**Final Report**

**WASTE ISOLATION PILOT PLANT**

**CONCEPTUAL MODELS  
SUPPLEMENTARY  
PEER REVIEW REPORT**

**December 1996**

Figure 3-1. Cumulative total brine inflow into the undisturbed repository.

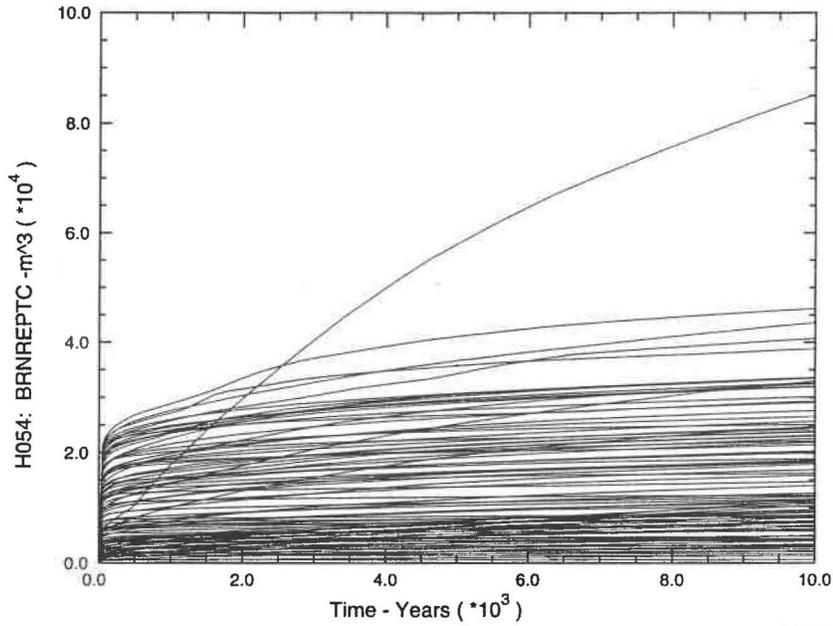
In evaluating the response to the first concern (potential restrictions to brine flow resulting from shallow cell depths in the two-dimensional BRAGFLO model), the Panel did not consider the comparison of two- and three-dimensional model results to be adequate because the analyses included an E2 intrusion at 1,000 years which would have caused radial flow, and because the comparison was based on combined inflows in the two-dimensional model into both the single panel and the “rest of the repository.” This comparison, therefore, included flow into the southern half of the single panel that did not cross the narrow constriction created by the borehole cells. Thus, it did not adequately test the ability of brine to cross that constriction and enter the “rest of the repository,” which constitutes approximately 90% of the waste area volume. A more robust test would have been a comparison under undisturbed conditions of flow to and from the “rest of the repository,” which would have evaluated non-radial flow crossing both the constriction at the shaft and that at the borehole. In addition, the constrictions could potentially introduce a significant systematic bias into the modeling results.

In subsequent discussion of the first concern with SNL personnel, it was recognized that the majority of the rapid, early-time brine flow into the undisturbed repository (up to about 20,000 m<sup>3</sup>) occurs because of drainage from the DRZ (Figure 3-1), which is considerably larger than the volume (up to about 6,000 m<sup>3</sup>) that results from inflow from all anhydrite interbeds (Figure 3-2). Considering only the shaft constriction, the maximum difference in both repository inflow and outflow between the two-dimensional and three-dimensional model results was identified in the aforementioned FEP S-1 study to be about  $1 \times 10^6$  kg of brine, or about 800 m<sup>3</sup> at a brine density of 1,230 kg/m<sup>3</sup>. If both the shaft and borehole constrictions were considered, the difference is unlikely to exceed 2,000 m<sup>3</sup>. This volume is small compared with the approximately 20,000 m<sup>3</sup> that can enter by drainage from the DRZ, and its importance would diminish further in any realization involving an intrusion because the two-dimensional model is designed to simulate the radial flow induced by those intrusions. The influence of the constrictions is significantly greater for brine outflow, where FEP S-1 results indicate that the actual outflow may be on the order of twice that predicted by the two-dimensional model. This is considered conservative, however, because the total outflow volume is relatively small (generally less than 2,000 m<sup>3</sup>)

and the presence of extra brine in the repository is expected to increase calculated releases. In view of the relatively small fluid volume involved, this first issue is considered to be adequately resolved on the basis of a lack of consequence. However, if subsequent model modifications result in significantly smaller fluid volumes in the repository, the significance of this issue should be reevaluated.

Figure 3-4. Cumulative brine inflow into operations area under undisturbed conditions.

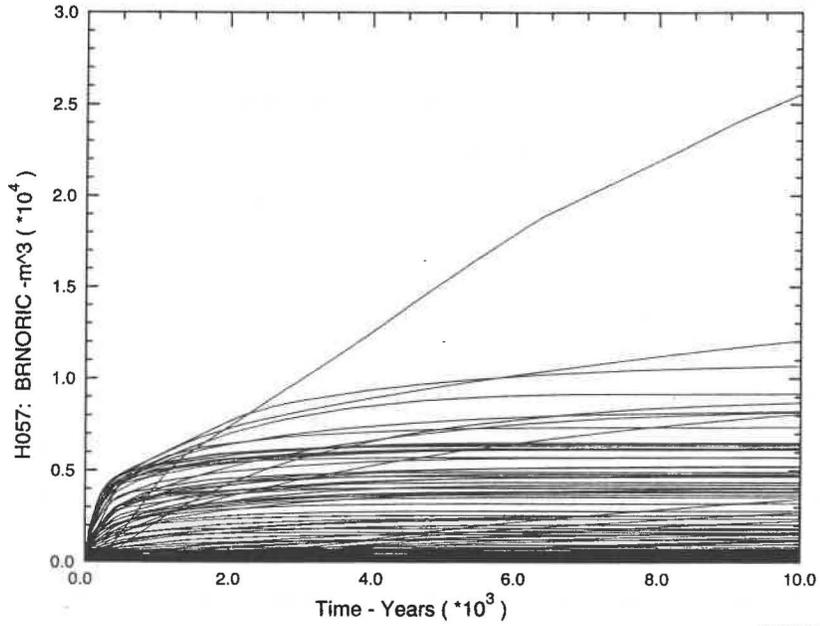
In evaluating the response to the first concern, the Panel concurs with the DOE that, based on the performance assessment modeling results, the consequences of borehole penetrations in the operations and experimental areas are not expected to be significant. It is agreed that no cuttings, cavings, or spallings releases would occur from such penetrations. DOE's response indicated that with very few exceptions, the maximum brine flow through a panel seal was found in modeling results to be about 12,000 m<sup>3</sup> following an E1 intrusion, and the expected flow would be about 3,000 m<sup>3</sup>. Under undisturbed conditions, the cumulative brine inflow into the operations and experimental areas from all sources ranges from near zero to about 10,000 m<sup>3</sup> (see Figures 3-4 and 3-5). This flow would, on the average, be expected to result in approximately a twofold dilution of brine flowing in from the waste area following an E1 intrusion. Under disturbed conditions with intrusion boreholes penetrating the operations and experimental areas, the inflow of uncontaminated brine and the dilution of contaminated brine would be even greater.

Figure 3-6. Cumulative brine flow into repository following an E1 intrusion at 1000 years.

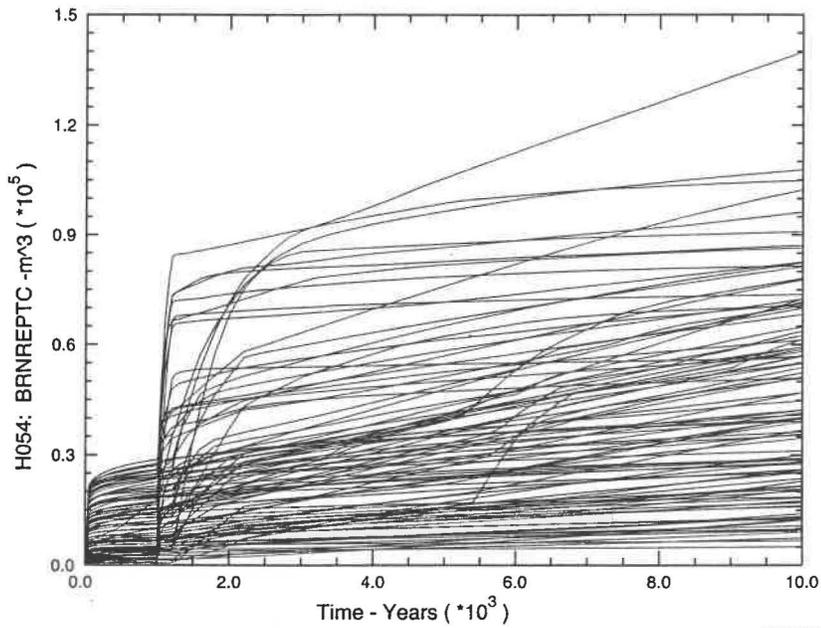
about 40,000 m<sup>3</sup> following an E1 intrusion at 1,000 years and about 30,000 m<sup>3</sup> following an E2 intrusion at 1,000 years (see Figures 3-6 and 3-7). Given that about six borehole intrusions are expected to occur during the regulatory time frame, the total volume of brine potentially available to flow into the waste area could exceed 100,000 m<sup>3</sup>. Although the actual volume of brine inflow will depend on the interrelationships among time of intrusion, repository creep closure, gas generation, repository pressure, and other factors, the modeling results indicate that sufficient brine is potentially available from other sources that an incremental supply of as much as 12,000 m<sup>3</sup> would have no consequential effect on performance assessment results. However, if subsequent model modifications result in significantly smaller fluid volumes in the repository, the significance of this issue should be reevaluated.

**Figure 3-8. Volume-averaged pressure in undisturbed waste panel.**

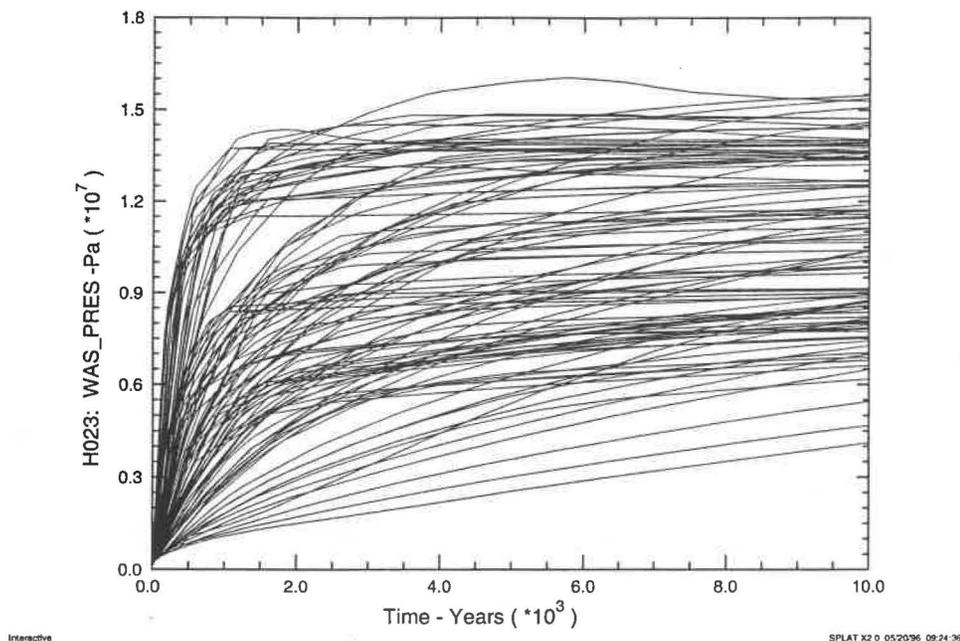
The fourth concern (sensitivity of performance assessment to the use of reference conditions) was addressed by DOE with reference to the plot of volume-averaged pressure simulations for an undisturbed waste panel shown in Figure 3-8. As previously stated, the Panel's primary concern was with the use of only two reference conditions (350 and 1,000 years) for evaluating E1 and E2 intrusions. These reference conditions were used by applying conditions at 350 years to intrusions occurring at or before 350 years, applying conditions at 1,000 years to intrusions occurring at or following 1,000 years, and linearly interpolating conditions for intrusions occurring between 350 and 1,000 years.

As shown in Figure 3-8, undisturbed, volume-averaged pressures are steeply climbing in virtually all realizations prior to 350 years, and applying the value at 350 years is conservative. Between 350 and 1,000 years the increase is essentially linear, and the use of linear interpolation is appropriate. After 1,000 years approximately half the curves are reasonably flat; however, the other half of the curves show continuing pressure rises for the duration of the regulatory time frame. Because of this continuing pressure rise, the assumption of constant pressure after 1,000 years is nonconservative for many realizations and may not be appropriate. Undisturbed, volume-averaged brine saturations in the waste panel and rest of the repository are shown in Figure 3-9. Again, the Panel's greatest concern is with the adequacy of assuming constant conditions after 1,000 years. The performance assessment results, however, indicate that the consequences of this concern are expected to be low. The short-term cavings, spillings, and direct brine releases, which are of primary importance to waste isolation, are computed based on a larger number of reference conditions which the Panel expects to be adequate. The two cited reference conditions associated with this concern are used only to determine long-term releases and to provide a basis for calculating releases for second and subsequent intrusions for the short-term releases.

Long-term releases occur via the Culebra or the anhydrite interbeds, and releases by these pathways were found in performance assessment modeling to be zero or insignificant. Second and subsequent releases were also found to not be significant because of repository pressure relief following the first penetration. Although the Panel continues to question the accuracy of results based on only two reference conditions, the concern has been adequately addressed on the basis of a lack of consequence.

Figure 3-10. Net brine inflow into waste panel for E1 penetration at 350 years.

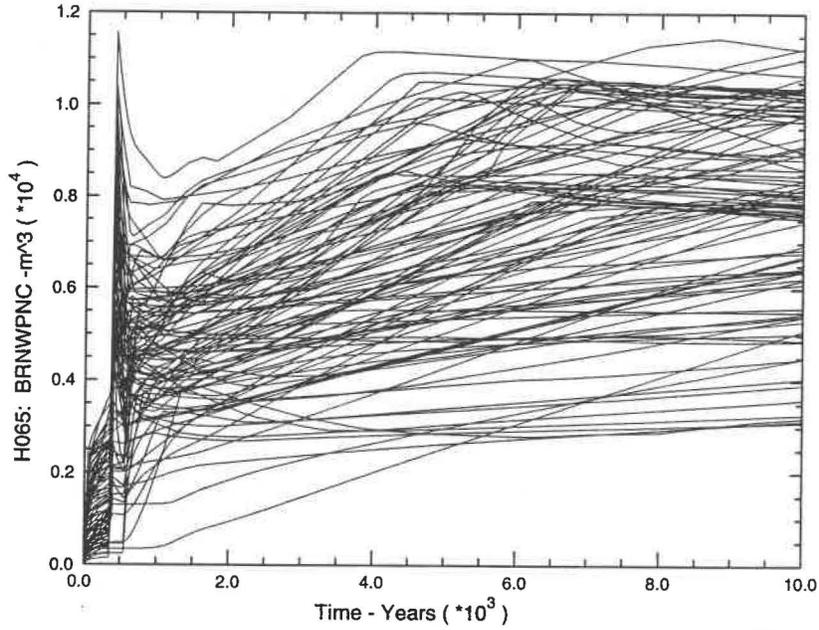
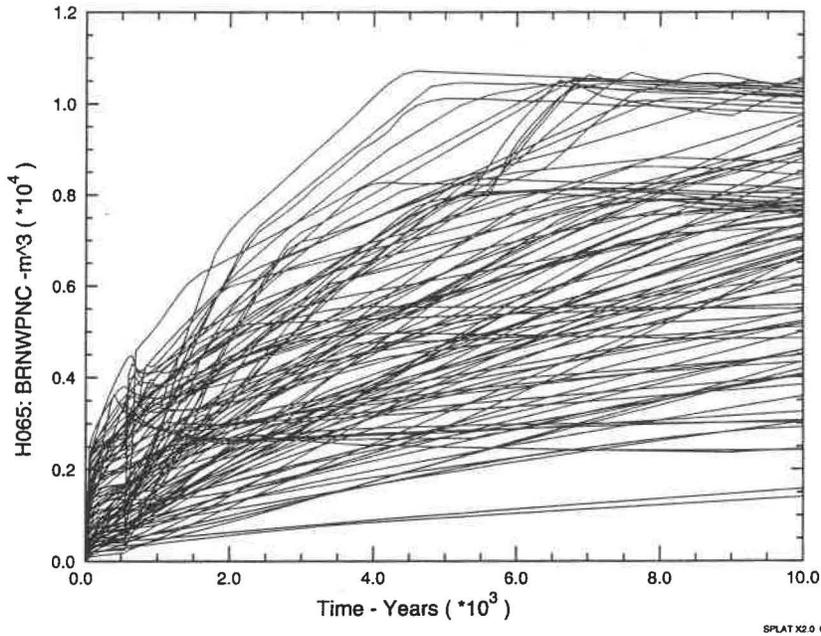
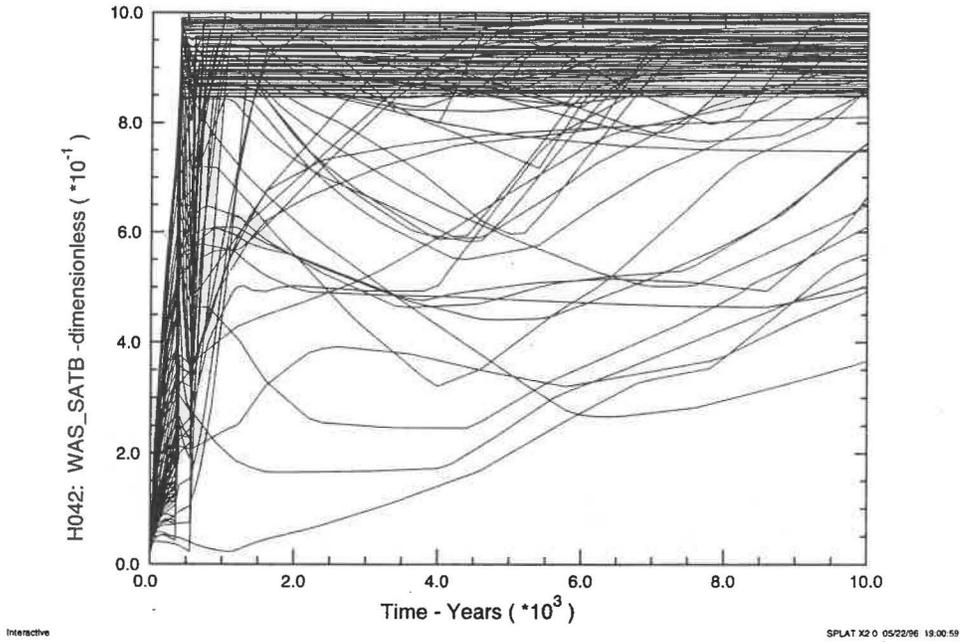
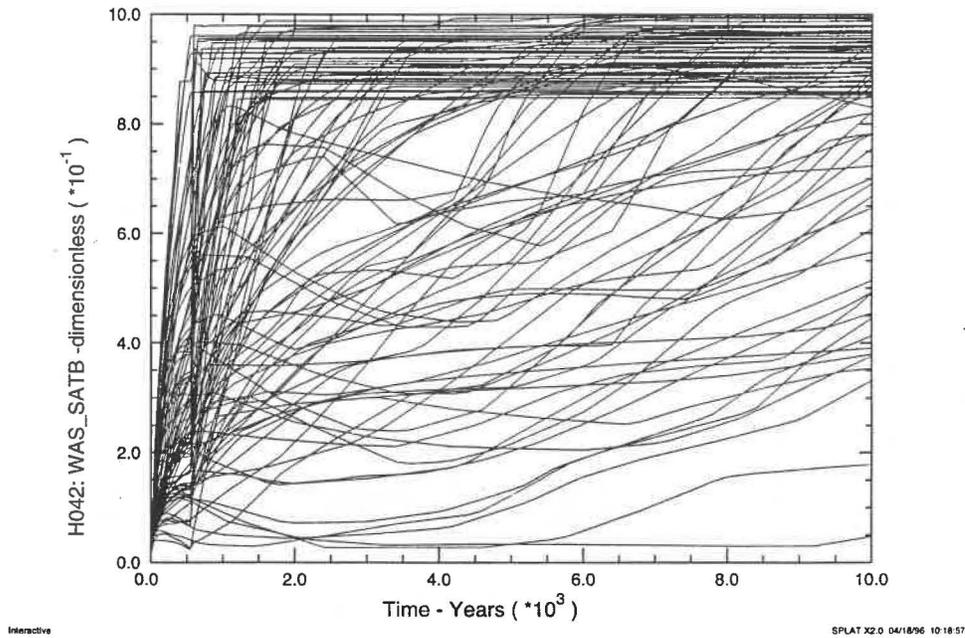
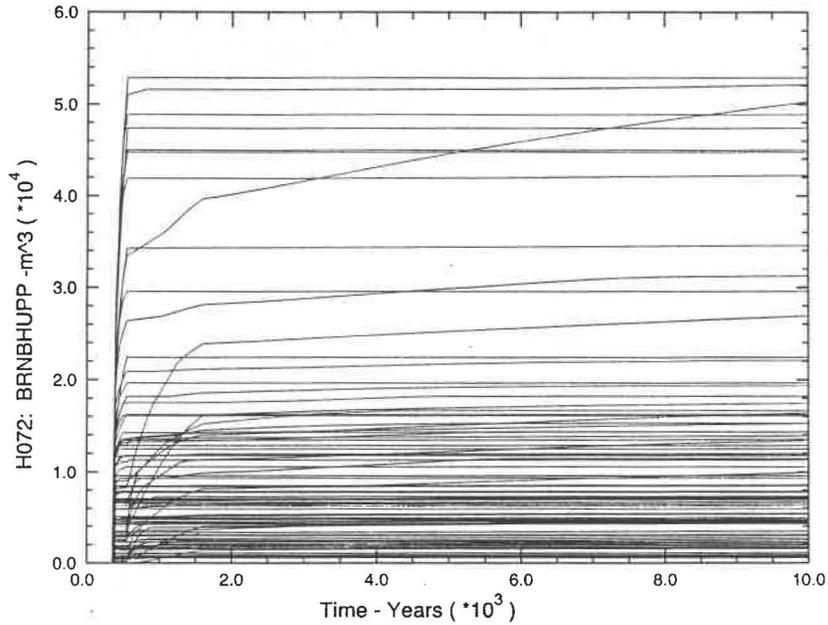
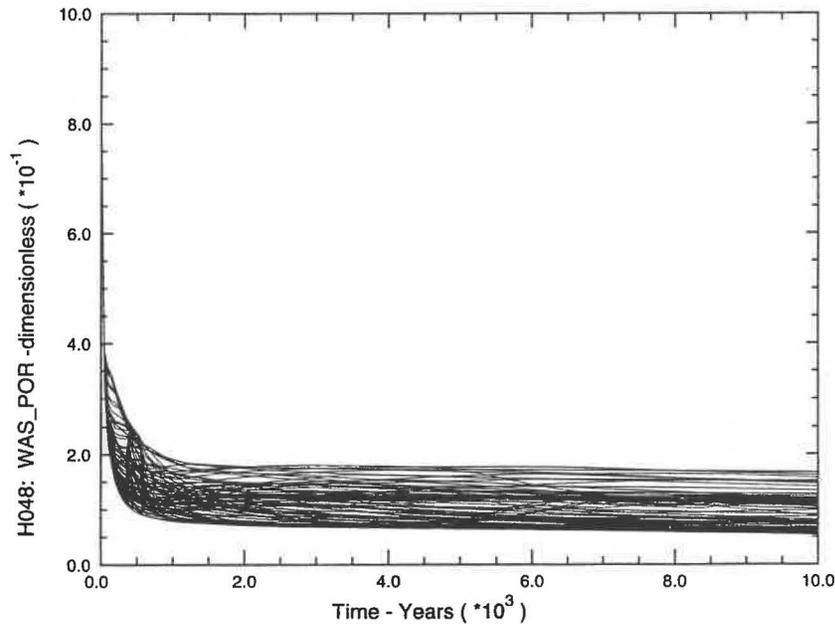
A lack of consequence was demonstrated by DOE for the third concern by comparing the long-term effects on the repository and on spillings releases of E1 and E2 intrusions. These comparisons are intended to show that the differences between a reservoir hit and no-hit are not highly significant. Noting that the total number of boreholes penetrating the site is unchanged by this issue, by inference the differences created by increasing the number of hits and decreasing the number of no-hits should also not be significant. The differences between E1 and E2 intrusions are illustrated in Figures 3-10 through 3-18. The net brine inflow into the waste panel for E1 and E2 penetrations at 350 years is shown in Figures 3-10 and 3-11. While the early-time results differ, the longer-term results are similar, although the net inflow is on the average about 1,000 m<sup>3</sup> higher for an E1 than an E2. The volume-averaged brine saturation in the waste panel for E1 and E2 penetrations at 350 years is shown Figures 3-12 and 3-13. Here the results are similar for both the short- and long-term, although the number of lower saturation, outlying curves is smaller for the E1 than the E2 intrusions. Cumulative brine flow up the borehole at the bottom of the waste panel for an E1 penetration at 350 years is shown in Figure 3-14. Because the E2 borehole does not encounter a brine pocket, the corresponding E2 flow would be zero and the figure shows the incremental brine available to the repository from an E1 intrusion. Although the maximum volume in excess of 50,000 m<sup>3</sup> is significant, the volume is more typically less than 10,000 m<sup>3</sup> and is not significant in comparison with the overall volume of brine potentially available to the repository (see Section 3.12). The volume-averaged porosity in the waste panel for E1 and E2 intrusions at 350 years is shown in Figures 3-15 and 3-16. The difference between the curves is negligible. The total gas generated in the entire repository is shown for E1 and E2 intrusions at 350 years in Figures 3-17 and 3-18. Again, the difference is negligible. Spallings releases were also reviewed by the Panel for second E1 and E2 intrusions (note that spallings releases for first intrusions would be identical for E1s and E2s).

Because of the moderating effect of gas pressure reduction following the first intrusions, the differences between spallings releases for the second intrusions are not significant. In summary, the Panel agrees that the differences between E1 and E2 intrusions for key repository conditions and performance criteria are small and finds the DOE response to be acceptable on the basis of a lack of significant consequence. However, if subsequent model modifications result in significantly smaller fluid volumes in the repository, the significance of this issue should be reevaluated.

Figure 3-19. Phase diagram for the MgO - CO<sub>2</sub> system.

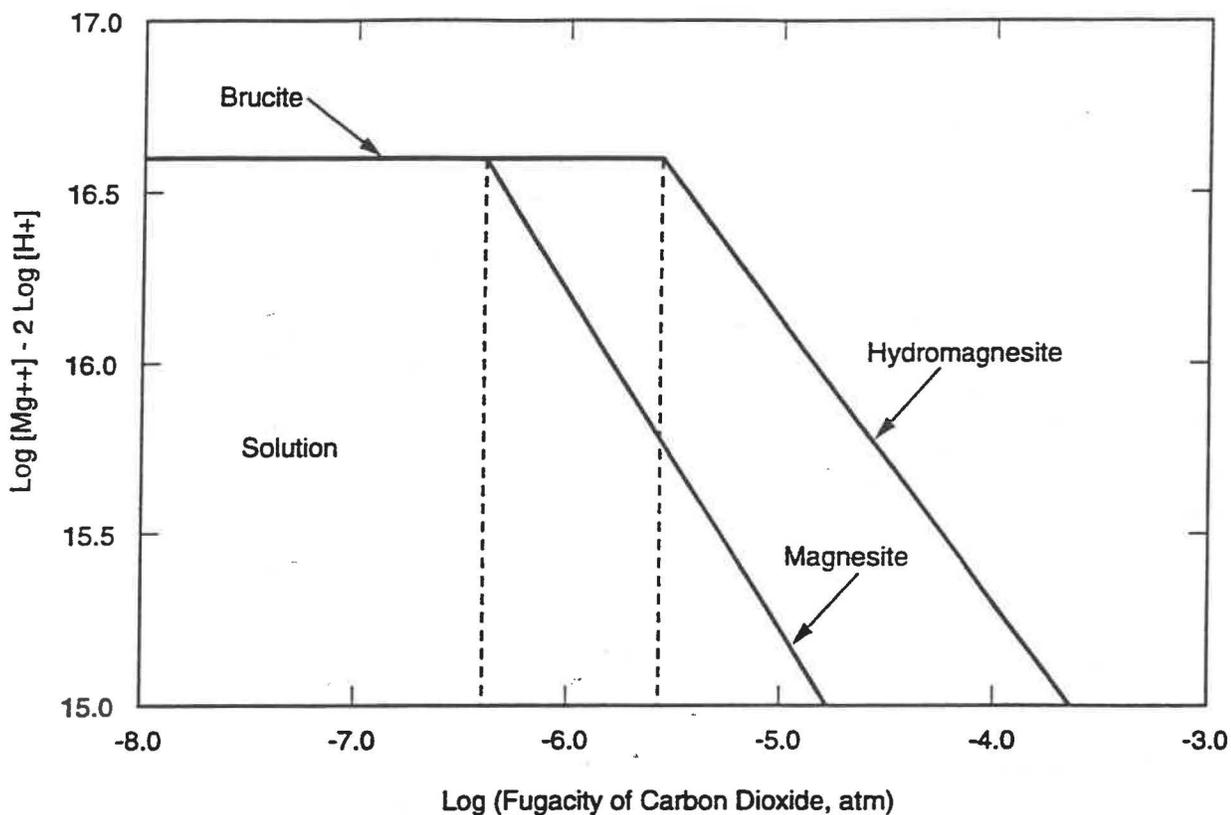
The second concern was that of phase stability and equilibria conditions in the repository. This information was thought necessary due to the large amount of MgO that would be emplaced in the waste cells. The phase diagram that was presented was limited to the system MgO-CO<sub>2</sub> (with excess H<sub>2</sub>O) and only portrayed stable phases (Figure 3-19).
